STAFF REPORT
Planning

Title: Official Plan Amendment 51, Zoning By-law Amendment Z-24-02, Lester Sunview Development Inc, 249-253 Sunview Street

Report Number: IPPW2024-016

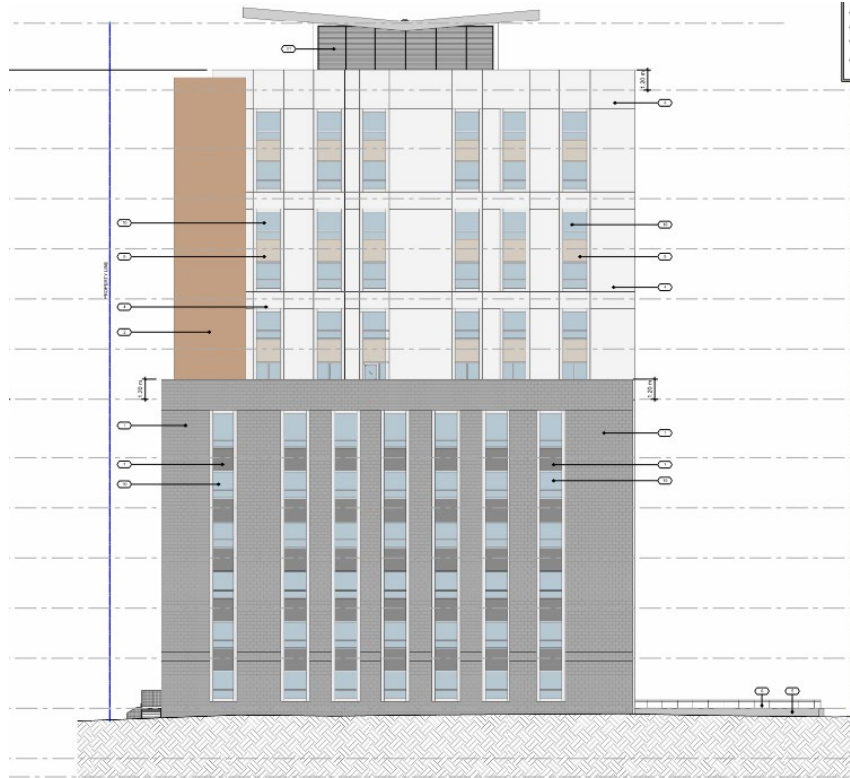
2. The Landscape Open Space Chart, Context Plan detail 3/S1.1B, shows stairs included in the Landscaped Open Space (LOS) calculation graphic, which would not meet the City's by-law definition. Staff understand the calculation included on the Site Plan of 27.82% to be accurate (i.e., to exclude the proposed stairs). Please advise if the LOS noted on the Site Plan (27.82%) is incorrect.
3. Staff appreciate the adjustments made to the site design that have increased the width of the perimeter landscape strips. Please explore possible ways to meet the required 30% LOS. For example, can the patio space expand south over one additional parking space to make up the LOS deficiency? It appears that the snow storage & staging area will be used for garbage staging, but if not, perhaps this space can be converted to sod/LOS.

East Elevation (Sunview Street)

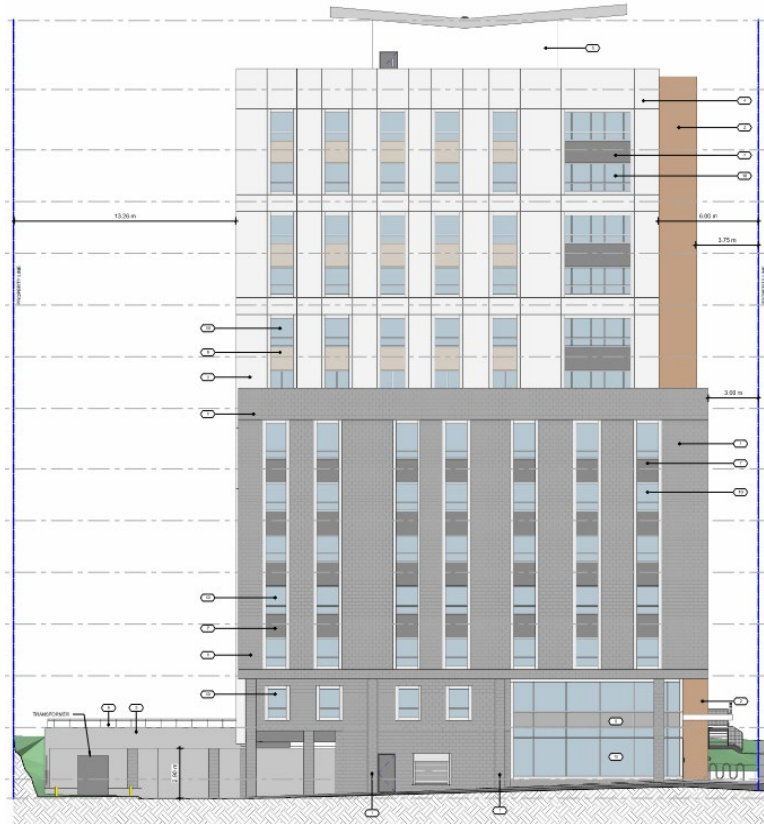
The Applicant is requesting relief to the maximum stair height and maximum stair projection to facilitate 2 pedestrian entrances from Sunview Street to the technical second storey at the north end of the building's front facade. Specifically, the Applicant is proposing a maximum stair height and projection of 2 metres from average grade, whereas a maximum stair height and projection of 0.6 metres is permitted.

The Applicant is proposing an architectural feature along the front building façade, which is currently not permitted as an architectural projection in Section 3.A.5(c) of Zoning By-law 2018-050 (see image below). The Applicant is proposing this feature to frame the balconies continuously between floors 4 to 13, which will in turn act as a privacy screen between balconies. The architectural feature will also add additional articulation and architectural variety to the front building façade:
